17 July, 2002  
LTR-NRC-02-36

**SUBJECT: WESTINGHOUSE RESPONSE TO NRC RAIs REGARDING WCAP-15689-P**  
**[ENCLOSURE 1-P CONTAINS WESTINGHOUSE PROPRIETARY CLASS 2 INFORMATION]**

## **WESTINGHOUSE NON-PROPRIETARY RESPONSE TO NRC RAIs REGARDING WCAP-15689-P**

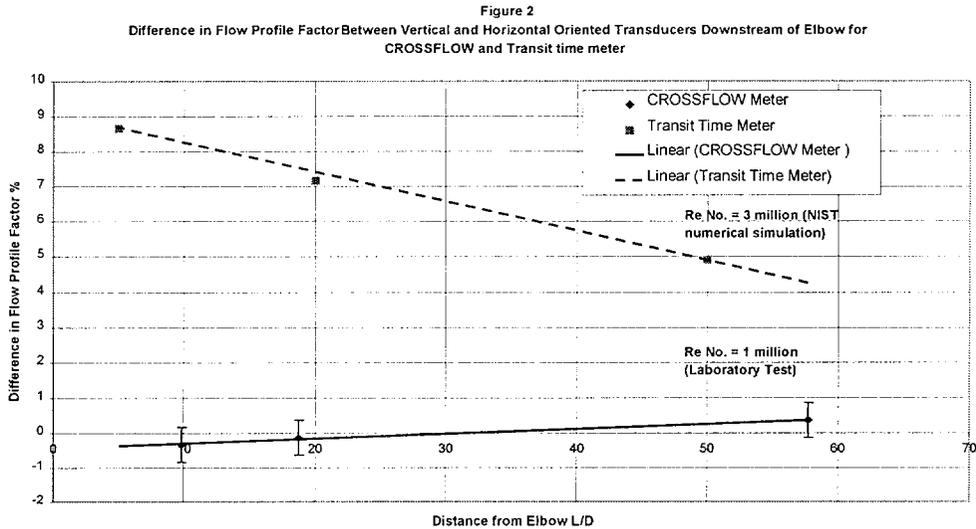
With respect to WCAP-15689-NP, Page 6, Section 2.4, 2<sup>nd</sup> paragraph and Figure 2:

This figure is marked proprietary in its entirety, however, the corresponding discussion of the figure is non-proprietary. Please provide a non-proprietary version of the figure, if possible, to facilitate writing of the NRC’s ER-262 evaluation report which will be in the public domain. Additionally, the lines drawn on the figure are indistinguishable from one another since the figure is not in color. Use of different line types would facilitate understanding the figural presentation.

The proprietary classification of Figure 2 has been removed so that the figure can be referenced in the NRC evaluation report. To facilitate the presentation, the sensitivity curve for the transit-time meter has been replaced by a dashed line to delineate it from the corresponding curve for the CROSSFLOW meter. The revised figure is shown below and has been downgraded from its former proprietary status to facilitate NRC use.
